Access Compliance Report

Public Rights-of-Way (Curb Ramps)

Intersection ID: 10031919	Main Street: MOCKINGBIRD_LN	Cross Street: N/A	Location: SW
ADA ID: 7F6913FC4174	Ramp Type: Perp	Initial Pass/Fail: Pass	Overall Compliance: No
Codes/Mitigation Info/Possible Solution		Field Measurements/Component Compliance	
Severity Score: 15.25

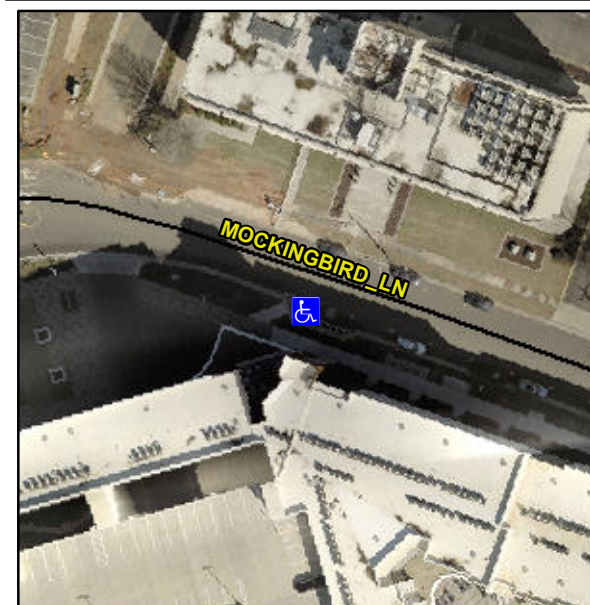
**Not Found, R304.5.3, R304.2.2-Perp,
R304.3.2-Para, R305, R304.5.4**

Compliance	Description	Data	Compliance	Description	Data
N/A	Ramp Length (in)	64.0	Yes	Ramp Slope (%)	7.4
Yes	Ramp Width (in)	64.0	No	Ramp XSlope (%)	2.3
Yes	Flare Type L	Curbed_NoWalkSurface	Yes	Flare Type RT	N/A
Yes	Flare Slope LT (%)	N/A	N/A	Flare Slope RT (%)	N/A
N/A	Flare Traversable LT?	No	N/A	Flare Traversable RT?	No
Yes	Landing Length (in)	80.5	No	DWS Provided?	No
Yes	Landing Width (in)	82.5	N/A	DWS Contrast?	No
No	Landing Slope (%)	3.5	N/A	DWS Length (in)	N/A
No	Landing X Slope (%)	2.7	N/A	DWS Full Width?	No
N/A	Landing Curb? (Y/N)	No	N/A	DWS Offset (in)	N/A
N/A	Shared Landing?	No			
Yes	Gutter Ponding?	No	No	Gutter Slope (%)	6.8
Yes	Gutter Lip Ht (in)	0.0	Yes	Gutter X Slope (%)	0.2
N/A	Painted X Walk1?	No	N/A	Painted X Walk2?	N/A
	X Walk 1 Direction	To N		X Walk 2 Direction	N/A
N/A	X Walk 1 Width (in)	N/A	N/A	X Walk 2 Width (in)	N/A
	X Walk 1 Slope (%)	0.4		X Walk 2 Slope (%)	N/A
	X Walk 1 X Slope (%)	0.4		X Walk 2 X Slope (%)	N/A

**Remove & Replace Entire Ramp.
Remove & Replace Gutter.**
